**Planning, Development  
and Transportation**  
Transportation Planning  
305 Chestnut Street  
PO Box 1810  
Wilmington, NC 28402-1810

■ **WOODLANDS AT ECHO FARMS TRACT 3C [TRC Plan Review]**

↻ Initial Review Note ↻

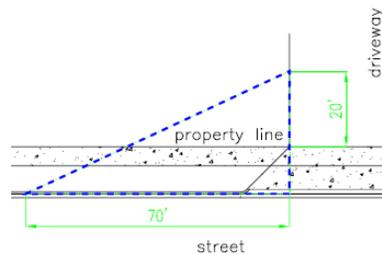
1. The roundabout and one-way street section appears to be acting as a cul-de-sac. This Cul-de-sac off Appleton Way exceeds the maximum length of 500'. [[Chapter VII, Sec.B \(2\) CofWTSSM](#)]

2. The intersections of Echo Farms Blvd. and the new Street A and are closer than the 400' minimum distance per the City's technical standards. [[7-5 CofW Tech Stds](#)]

3. Show a cross-section detail showing the One-Way Street ROW and Parking and the proposed roundabout.
4. Show centerline geometry of one way streets.
5. Install wheelchair ramp at each street corner where sidewalk and crossing locations are present, per NCDOT and/or City standards. Connect sidewalk with ramp.

6. The minimum horizontal centerline radius is 100' for local roads and 200' for collector streets.
7. The minimum tangent length between reverse curves is 100'. Verify this measurement for the One-Way Streets.

8. The minimum street corner radii is 35'. [[7-5 CofW Tech Stds](#)]
9. All on street parking shall be at least 15' from fire hydrants. Please verify spacing from parking.
